**Town of Clarkstown
New City , New York
Highway Garage Expansion Project
Bid Number 21-2024**

**Addendum No. 1
August 16, 2024**

Subject: Town of Clarkstown
Highway Garage Expansion Project
Bid No. 21-2024

OVERALL EGRESS PLAN

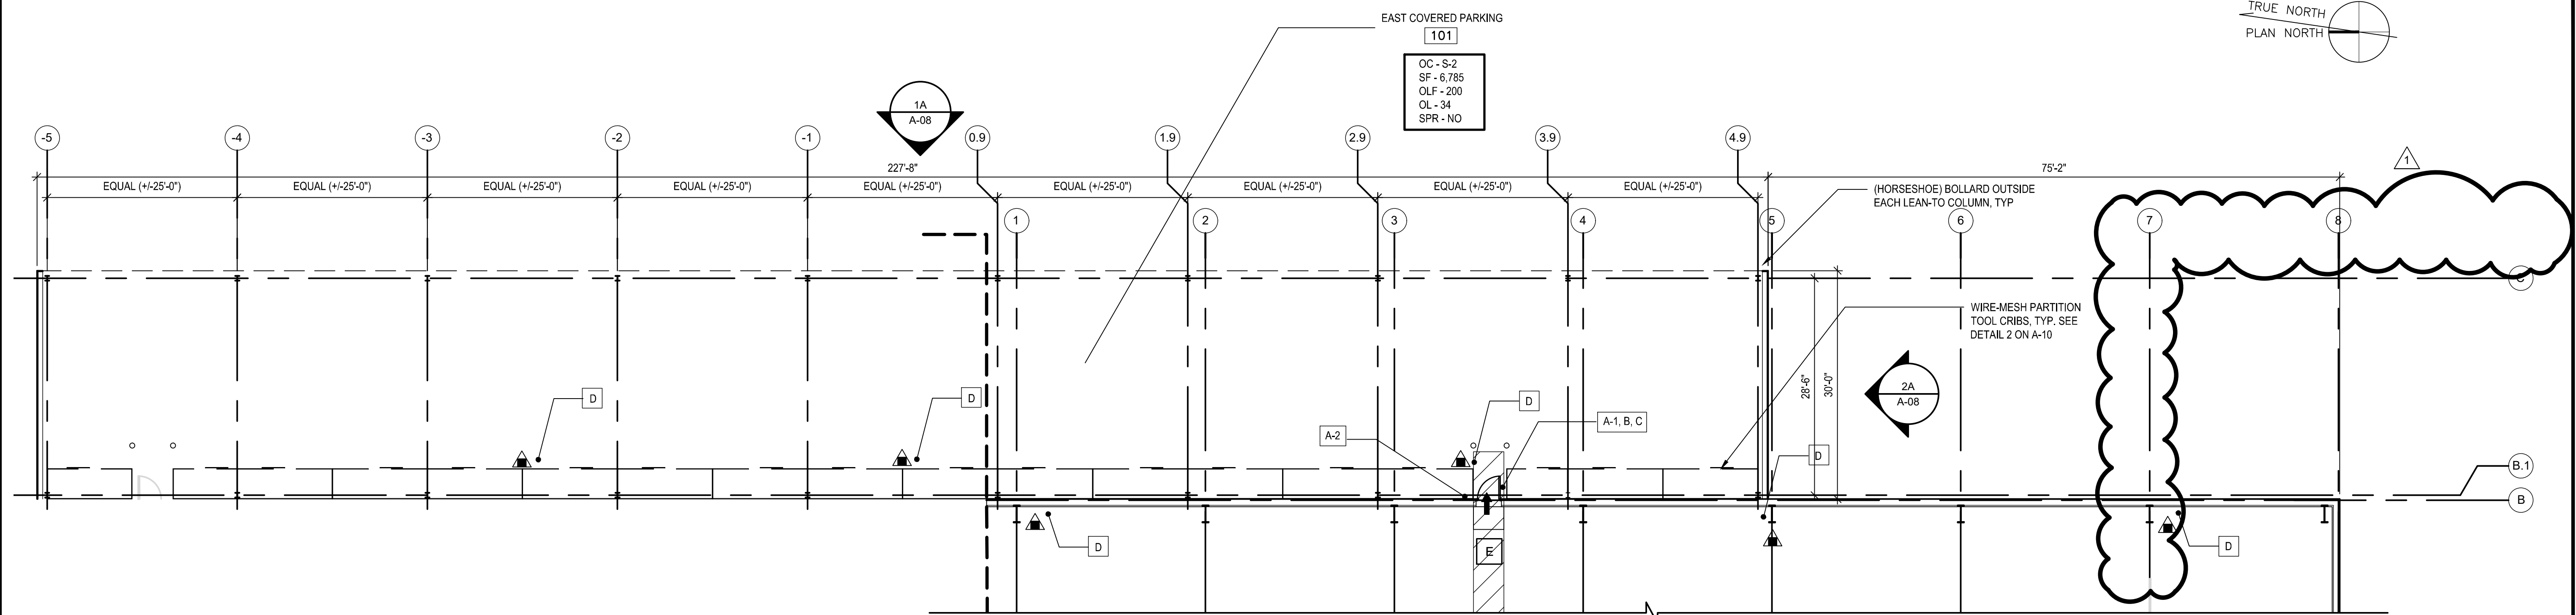
1. Sheet A-02, General Code Table change.
2. Sheet A-06, Lean-to Floor Plan changes.
3. Sheet A-08, North elevation 3A, changed colors.
4. Sheet A-09, Detail 3, corrected existing building materials to all CMU walls.
5. Sheet A-10, Detail 5, extended closet CMU walls to interior face of girts.
6. Sheet A-12, Louver Schedule, made correction to match West Elevation on Sheet A-07.
